PRELIMINARY 4 OXFORD ST
Chevy Chase Village Historic District

#### HISTORIC PRESERVATION COMMISSION STAFF REPORT

**Address:** 4 Oxford Street, Chevy Chase

**Preliminary Consultation**

PROPOSED SITE PLAN

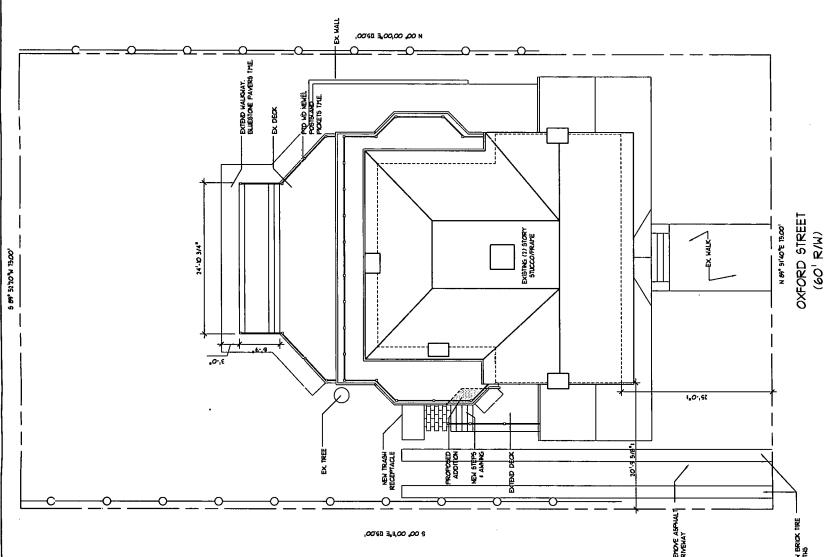
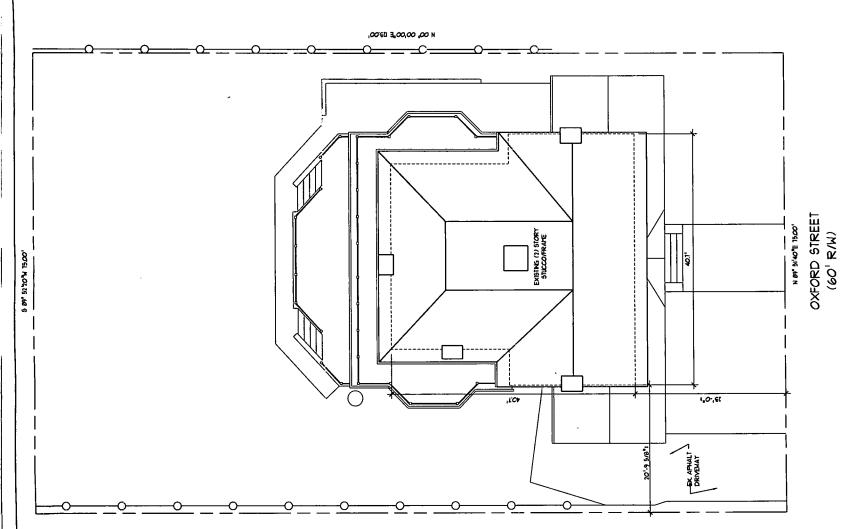
I re-reviewed the preliminary plans for 4 Oxford Street. The only issue has to do with a tree noted on the plans in the east side of the property, essentially between the proposed new trash receptacle and the porch. While there is no work proposed in the immediate vicinity of this tree, it will need a preservation plan outlined to protect it from the workers, equipment and storage of materials. I have advised the contractor of this and he was suppose to get me the paperwork and filing fee to get Bill Dunn out there to take a look at it. I have yet to receive anything. Under the circumstances. I will try to get Bill Dunn out to the site sometime tomorrow to look at the tree and I will advise you of the results upon receipt.
